Appendix 14F - Stage 1 Road Safety Audit

Ballynisky Green Energy Ltd.

This report details the findings of a Stage 1 Road Safety Audit carried out on the proposed Ballynisky Wind Farm temporary construction site access and permanent site access on the L1219 Local Road, County Limerick. The audit was commissioned by Ballynisky Green Energy Ltd.

Figure 2: Proposed Ballynisky Wind Farm Accesses Location Map

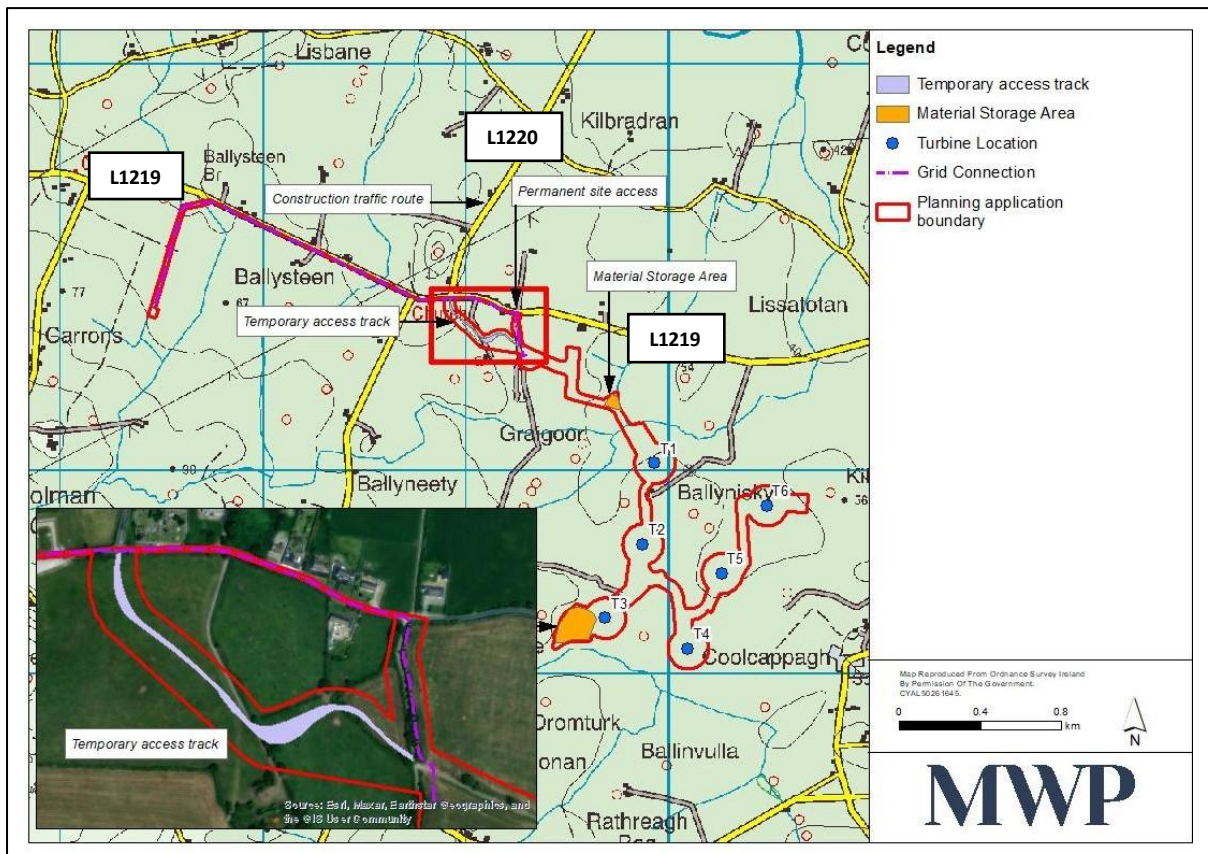
Visibility splay distances of 90 metres are shown for both the temporary construction site access and permanent site access junction on the L1219. The proposed visibility splay distances require existing boundary/hedgerow clearances on both sides of both accesses, and on both sides of the L1219. The existing L1219 in the vicinity of the proposed accesses has a restricted road carriageway width and alignment, resulting in vehicle speeds, observed during the site inspection, less than the posted speed limit. The boundary/hedgerow clearance works identified for the proposed 90 metres visibility splays could increase vehicle speeds, locally, on the L1219, increasing the risk and severity of vehicle collisions.

Recommendation:

It is recommended that appropriate visibility splays and stopping sight distances should be provided for both access junctions, commensurate with the L1219 design speed, with reference to TII's Rural Link Design and Geometric Design of Junctions.

Paragraph No. in Safety Audit	To Be Completed By Designer			To Be Completed by Audit Team Leader
	Problem Accepted (Yes/ No)	Recommended Measure Accepted (Yes/ No)	Describe Alternative Measure(s). Give Reasons for Not Accepting Recommended Measure	Alternative Measures Accepted by Auditors (Yes/ No)
2.1	Y	Y		
2.2	Y	Y		
2.3	Y	Y		
2.4	Y	Y		
2.5	Y	Y		
2.6	Y	N	The works required to address the recommended measure are outside the boundary of the proposed site. It is proposed to carry out the recommended measure only if permission to do so is provided by Limerick City and County Council, the owner of the works area and any/all other stakeholders.	Yes
2.7	Y	Y		
2.8	Y	Y
